MEMORANDUM

RE: New Richmond – Federal Foam; warehouse expansion

The City has received plans for construction of a 100,650 square foot warehouse building within the New Richmond Business and Technical Park. The proposed building is an expansion of Federal Foam's existing facility located southwest of Cernohous Avenue and Wisconsin Drive and will be connected to the existing building by an enclosed breezeway. The proposed development requires site plan review in accordance with Section 121-30 of the Zoning Ordinance that is subject to review and approval of the Development Review Committee. Federal Foam has also applied for a conditional use permit to allow for exterior materials other than that required by the Zoning Ordinance for buildings within the Z7 District in accordance with Section 121-32 of the Zoning Ordinance that is subject to approval by the Plan Commission. A public hearing to consider the conditional use permit application has been noticed for the Plan Commission meeting on 8 May 2018, which was continued to the Plan Commission meeting on 15 May 2018 to allow the developer to submit revised plans.

**NEW WAREHOUSE ADDITION FOR:
FEDERAL FOAM TECHNOLOGIES, INC.
600 WI

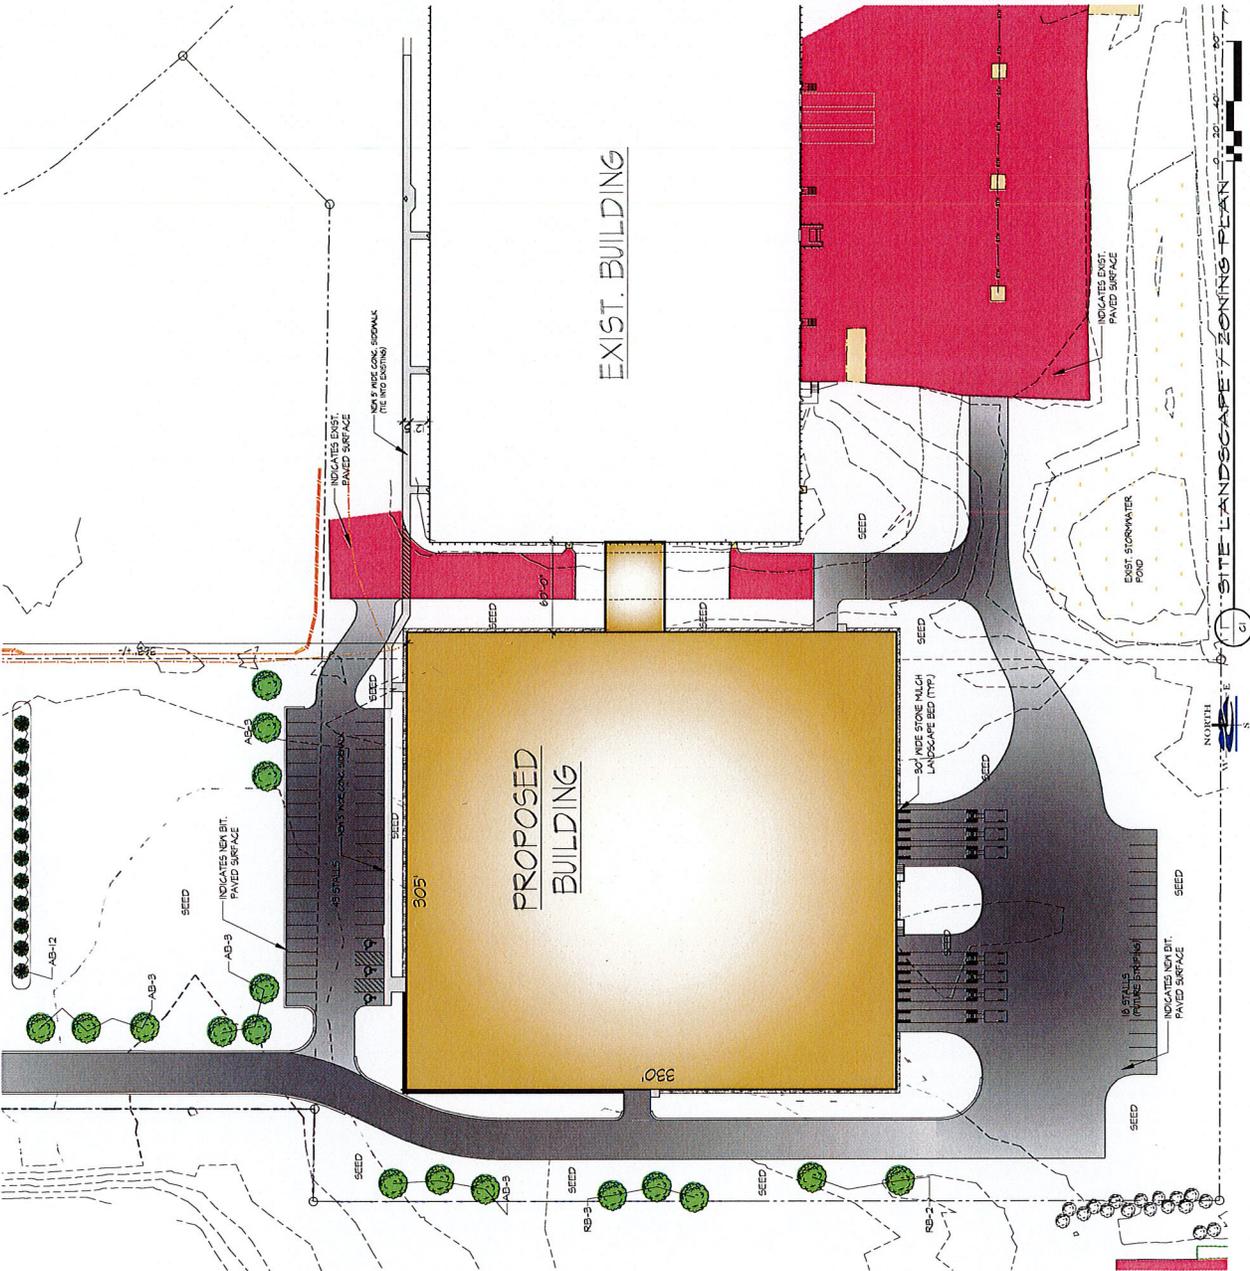
Landscaping. A landscape plan has been provided and is subject to the requirements of Section 121-55 of the Zoning Ordinance. Table 15 of the Zoning Ordinance requires the greater of one tree per 5,000 square feet of lot area or one tree per 100 feet of perimeter lot line, not to exceed 40 trees as the building area is greater than 40,000 square feet. A total of 37 trees are required for the proposed combined lot. There are eight existing trees in the yard of the proposed lot in the yard abutting Cernohous Avenue. The proposed landscape plan adds 29 additional trees for a total of 37 trees, which complies with the number required. The type sizes of proposed trees complies with Sections 121-55.D and E of the Zoning Ordinance. Section 121-55.I.2 of the Zoning Ordinance requires the developer to provide a financial guarantee equal to 125 percent of the cost for materials and labor for the proposed landscape plan. The security is to be held by the City until it is verified that all plantings have survived through two winter seasons between October 31 and April 30.

Trash Storage. No exterior refuse area is shown on the site plan and no trash room storage area is identified on the building floor plans. Section 121-48.C of the Zoning Ordinance requires exterior storage of waste and recycling containers be screened by an enclosure. If exterior storage of trash containers is intended, an enclosure is required to be constructed of materials consistent with that of the principal building that will completely screen the view of the trash containers.

- A. Motion to **approve** site plan and a conditional use permit for exterior materials for Federal Foam, subject to the following conditions:
1. The developer shall provide a financial guarantee equal to 125 percent of the cost for materials and labor for proposed landscape plan to be held by the City until it is verified that all plantings have survived through two winter seasons between October 31 and April 30.

2. Any exterior storage of waste and recycling containers must be screened by an enclosure as required by Section 121-48.C of the Zoning Ordinance.
 3. A photometric lighting plan illustrating the location and intensity of proposed exterior lighting fixtures complying with Section 121-51.A.1 of the Zoning Ordinance and is subject to review and approval of the Zoning Administrator.

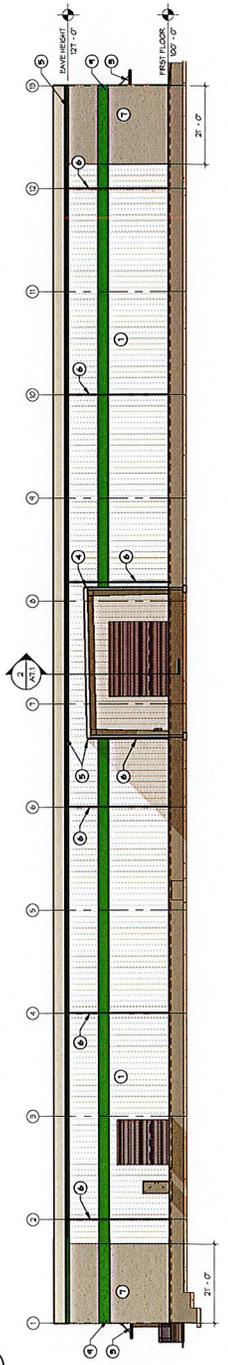
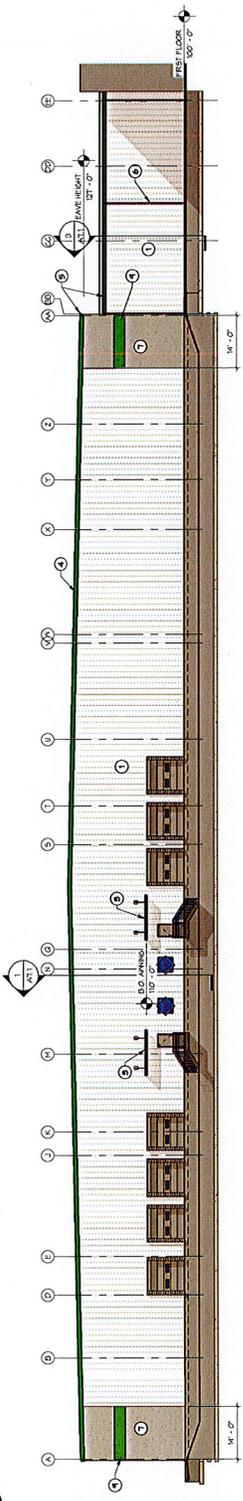
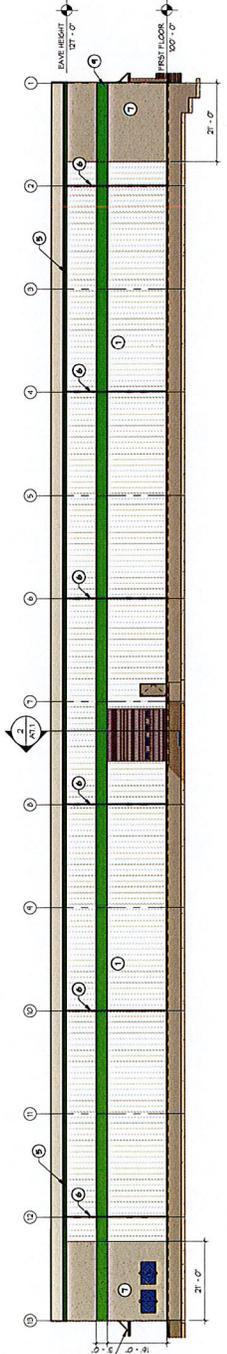
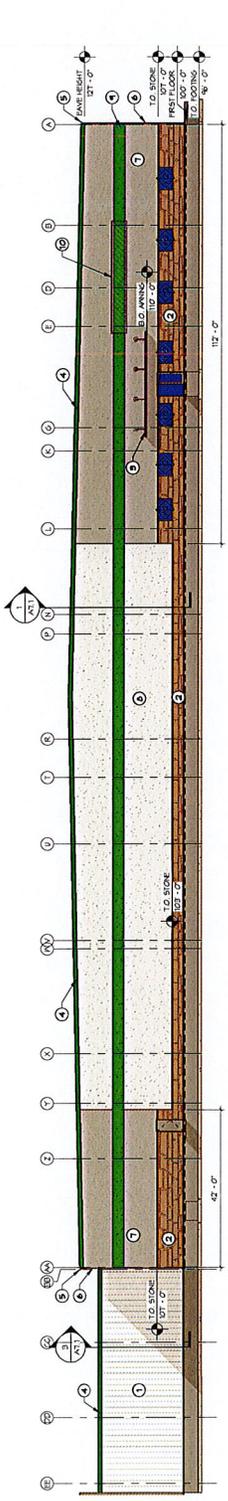
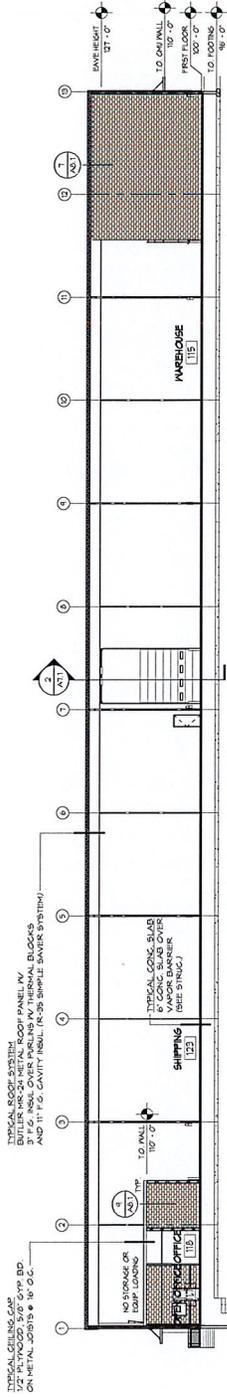
The exterior elevations of the proposed building have less than 50 percent masonry finish including the north elevation facing Wisconsin Drive and do not comply with the requirements of the Zoning Ordinance. The primary finish material on the north elevation and at the southeast and southwest corners is a Texturewall metal panel that has a surface appearance similar to masonry panels or stucco/EIFS. There is also a brick veneer wainscoting at the base of the Texturewall panels and surrounding the windows and door of the office portion of the building. The primary finish on the west, south, and east elevations is a prefinished metal panel.

The Zoning Ordinance allows that where buildings are not visible from residential uses, exceptions to the exterior finish requirements may be allowed administratively; the proposed building is not visible to surrounding residential uses. Section 121-49.G.4 allows further exceptions to the exterior finish requirements by approval of a conditional use permit subject to the Plan Commission making findings that:

- a. The proposed building maintains the quality and value intended by [the Zoning Ordinance].
- b. The proposed building is compatible and in harmony with other structures within the district.

C300 - SITE PLAN

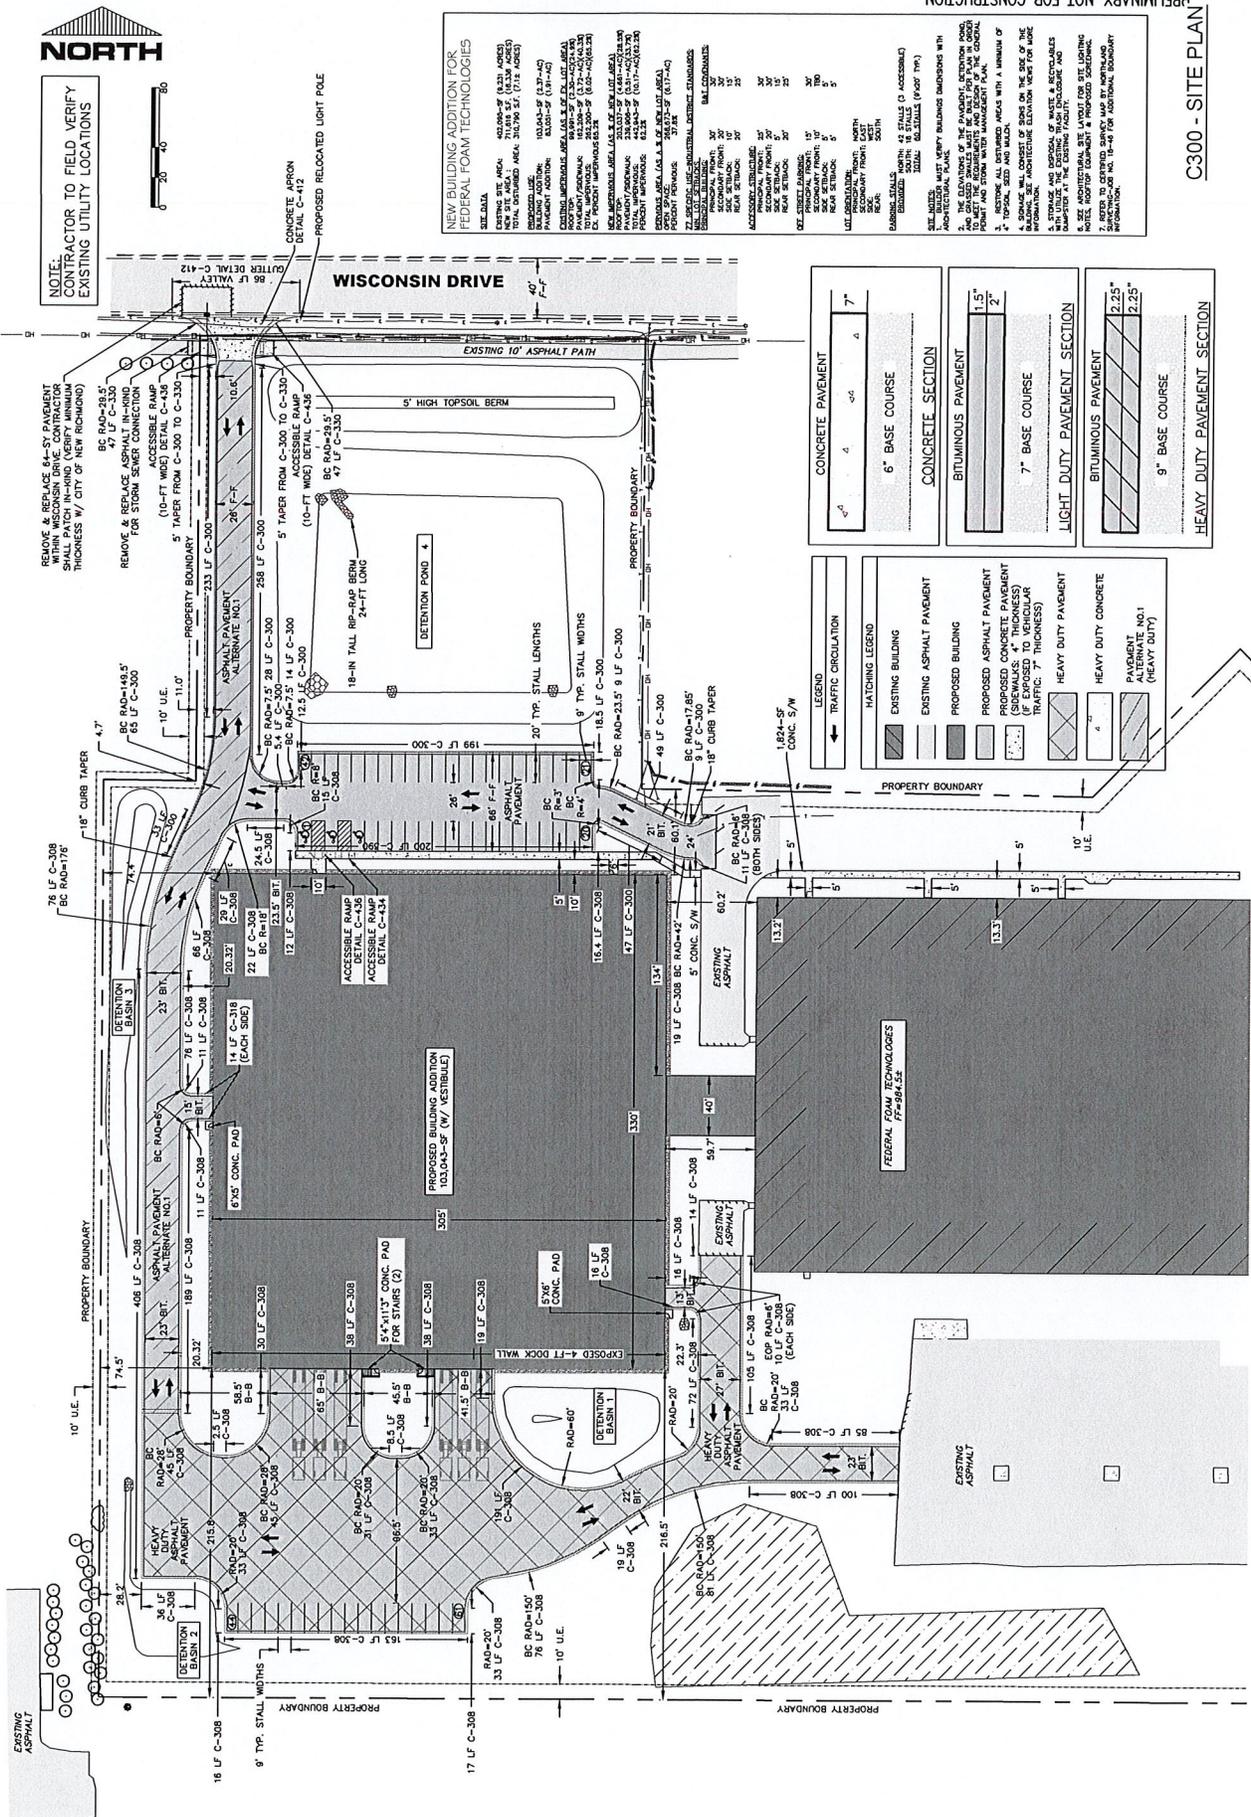
Access. Section 70-39 of the City Code limits each property to one driveway and driveway width is limited to 26 feet. Exceptions to these requirements for site specific access and traffic circulation needs are allowed subject to the recommendation of the Public Works Director. The site plan includes the access to Cernohous Avenue for the existing building. The site plan provides for extension of the driveway south of the existing building west to access the loading docks on the south elevation of the proposed building, then circulating around the west side of

the proposed building and extending to an access to Wisconsin Drive. The proposed internal circulation and accesses to both Cenrohus Avenue and Wisconsin Drive is necessary for efficient truck movements. The proposed access to Wisconsin Drive also serves the employee parking lot to the north of the proposed building and would serve as the primary access if the lot is subdivided in the future with separation of the existing and proposed buildings with removal of the breezeway. There is also a second existing driveway to Wisconsin Drive at the northeast corner of the proposed lot that accesses employee parking to the north and east of the existing building. The parking area to the north of the proposed building will be connected to the drive aisle north of the existing building. All accesses comply with the width requirements of the Zoning Ordinance.

Pedestrian Access. A five foot wide concrete sidewalk is proposed along the width of the north building elevation between the proposed building and off-street parking area. There is an existing trail along Wisconsin Drive abutting the subject site. Pedestrians may walk along the drive aisle between the front of the building and Wisconsin Drive to reach the public trail.

Off-Street Parking. Table 14 of the Zoning Ordinance requires off-street parking stalls to be provided at one stall per two employees on the maximum shift, plus one stall per 2,000 square feet of building area. Federal Foam has provided information that there will be 18 employees on a shift for the proposed building, requiring nine parking stalls. The 100,650 square foot building requires at least 51 parking stalls based on the area of the building. A total of 60 off-street parking stalls are required and the site plan illustrates that 61 parking stalls are to be constructed north and south of the proposed building. The site plan shows 3 stalls designated as disability accessible located north of the proposed building to comply with ADA standards. Off-street parking stalls have dimensions of 9 feet by 20 feet and are accessed by 26 foot wide drive aisles as required by Table 13 of the Zoning Ordinance. The parking area is surfaced with asphalt or concrete and surrounded by perimeter curb in accordance with Section 121-52.A.5 of the Zoning Ordinance.

C400 - UTILITY PLAN

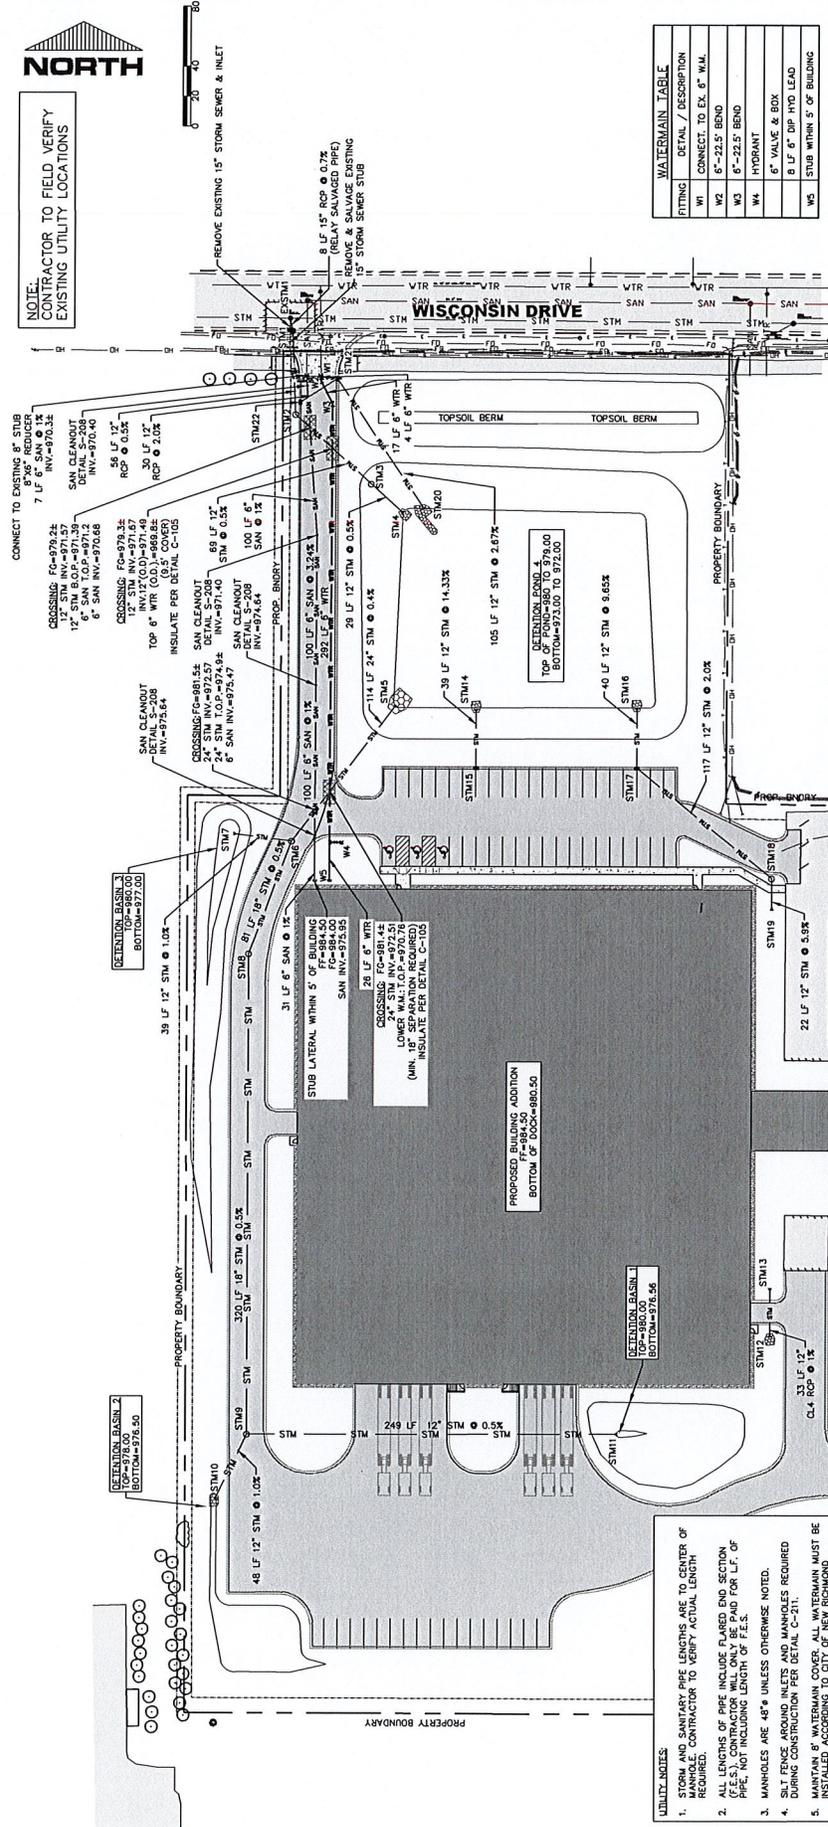
Utilities. Municipal utilities are available at the property, including sanitary sewer, water, and electric service. All utility issues are subject to review and approval of the Public Works Director.

6. All utility plans shall be subject to review and approval of the Public Works Director, and:
 - a. Cleanouts located within the pavement are recommended to be provided with a casting rather than the concrete with PVC.

- b. Confirm that the hydrant near the building can be built with the depth of the watermain at that location.
- B. Motion to **deny** the applications based on a finding that the request does not comply with the Zoning Ordinance and/or Subdivision Ordinance.
- C. Motion to **table** for further discussion.
- c. Michael Darrow, City Administrator
Jeremiah Wendt, Public Works Director
Sarah Skinner, Building Inspector
Nick Vivian, City Attorney
